April 28, 2022

RE: Coalition to Protect America's National Parks, National Parks Conservation Association and Sierra Club Comments on Arkansas Division of Environmental Quality's Proposed Regional Haze Planning Period II State Implementation Plan

Figure 2. Plum Point Historical SO₂ and NO_x Emissions.

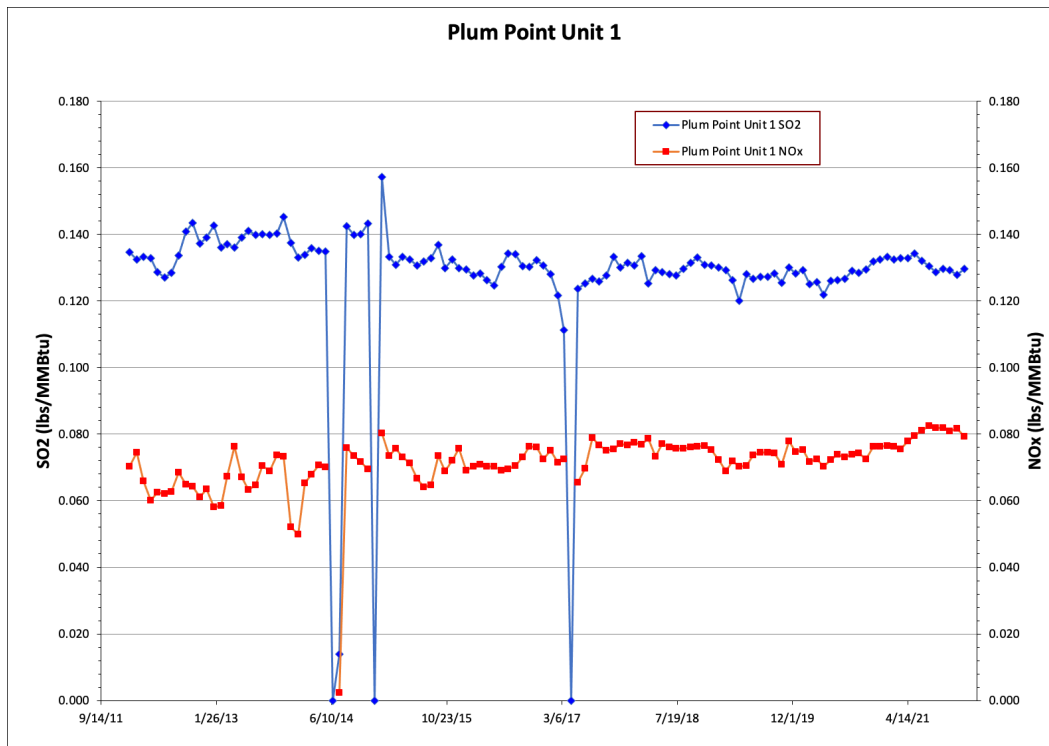
As can be seen Figure 2, Plum Point’s NOx emissions have been experiencing a gradual increase since at least 2012. This, and the fact that its SCR system is not performing at a level of 0.05 lbs/MMBtu, which is considered well controlled, indicates that its SCR system can be optimized or upgraded.
